Re: Preliminary Subdivision and Land Development - Berwyn Village II
SD-11-17-15184 - Easttown Township and Tredyffrin Township

A Preliminary Subdivision and Land Development Plan entitled "Berwyn Village II", prepared by DL Howell & Associates, Inc., and dated October 16, 2017, was received by this office on November 16, 2017. This plan is reviewed by the Chester County Planning Commission in accord with the provisions of Section 502 of the Pennsylvania Municipalities Planning Code. We offer the following comments on the proposed plan submission for your consideration.

Site Plan Detail, Sheet 2: Preliminary Subdivision and Land Development - Berwyn Village II

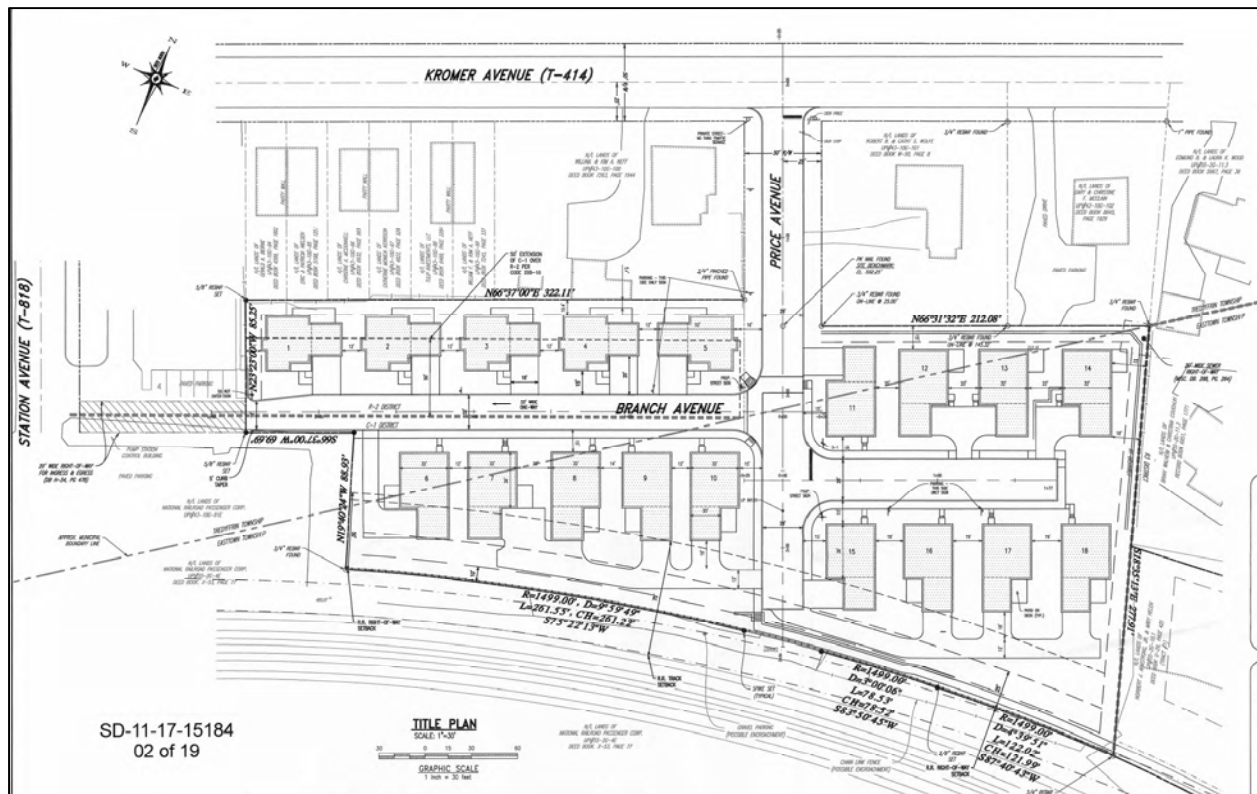
3. While we acknowledge, and endorse, that sidewalks will be provided for Units 6 through 18, we recommend that sidewalks be provided for all units, and the sidewalk network should be extended along Price Avenue to Kromer Avenue. Sidewalks are an essential design element in the **Suburban Center Landscape**.

The County Planning Commission recently reviewed a subdivision plan for the proposed "Berwyn Village" development to the east (CCPC# SD-09-17-15099, dated October 19, 2017). This subdivision plan depicts a 10 foot wide pedestrian easement on the south side of proposed Lot 7, and it appears that this pedestrian easement will connect to the proposed pedestrian network shown on the current "Berwyn Village II" development.

4. In its review of the proposed landscaping plan (Sheet 17), Easttown Township should verify that adequate landscaping/vegetative screening is provided between the residences and the adjoining railroad corridor to the south.
5. The Zoning Relief table on Sheet 1 indicates that, on July 27, 2017, the Tredyffrin Township Zoning Hearing Board granted seven variances for this project, with two conditions of approval. Prior to granting final plan approval, Tredyffrin Township should verify that the plan conforms to the decision issued by the Zoning Hearing Board.

While condition #2 of the Zoning Board decision states that the applicant shall provide adequate landscaping and fencing along the rear property line of units 1-5 and 11-13 in order to provide private and screening to/from the adjacent properties which front along Kromer Avenue, no landscaping is shown along the northern border on the landscaping plan (Sheet 17). This should be clarified by the applicant. We note that the 2011 Tredyffrin Township Historic Resources Atlas indicates that the adjoining parcel to the north on the southwest corner of Kromer Avenue and Price Avenue (UPI# 43-10G-100, 634 Kromer Avenue) contains a Class 2 historic resource.

6. We suggest that the applicant and Tredyffrin Township investigate the feasibility of shifting Units 1 through 5 closer to Branch Avenue, in order to provide a greater rear yard for these buildings.
